UNITED STATES PATENT AND TRADEMARK OFFICE

10/802,890

John K. Junkers

DETAILED ACTION

FIG. 4

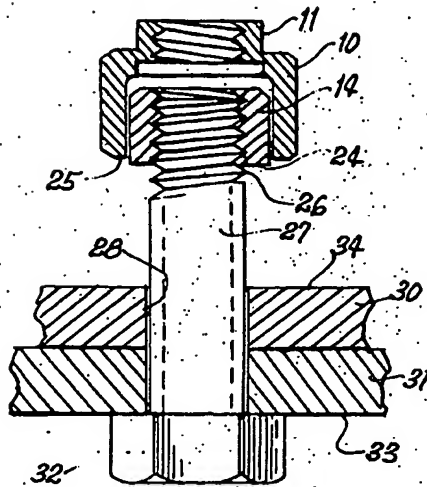
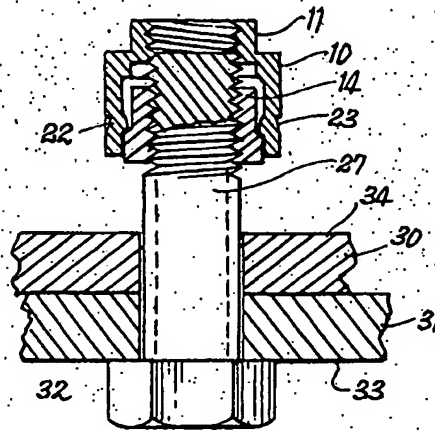
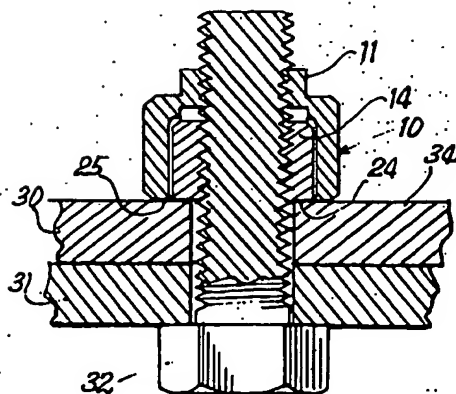
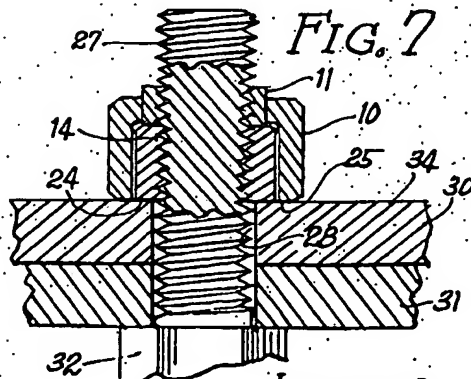
Grube teaches a washer with a body having an axis and first and second axial outer facial surfaces. Further, the washer has an additional turning resistant surface adapted to cooperate with a bolt, said additional turning resistant surface providing friction between the body and bolt to impede the bolt from turning and allowing the bolt to be axially displaced when the nut is turned (abstract Figs 4-7, col 3 line 59 - col 5 line 58). Grube Figs 4-7 teach the assembly of a washer in combination with the bolt.

Fig 4-7 show the turning resistant surface connectable with a bolt thread.

Fig. 4-7 show the body movable in the axial direction, and with one portion provided with said additional turning resistant surface and another portion frictionally connected to said one portion and provided with said second face surface which is adapted to frictionally cooperate with the object (at 24/25).

A breaking point is shown in Figs 6-7, which when broken when the bolt is turned, elongates the bolt in the axial direction.

First, examiner notes that claims 1-8 do not include the bolt or nut, and the washer stands alone, and thus either face can be considered the first or second face of the washer and either part 11, part 14, or the combination can be considered the washer. It is possible to add another lock nut onto the protruding shaft end 27, which is all the claims require.
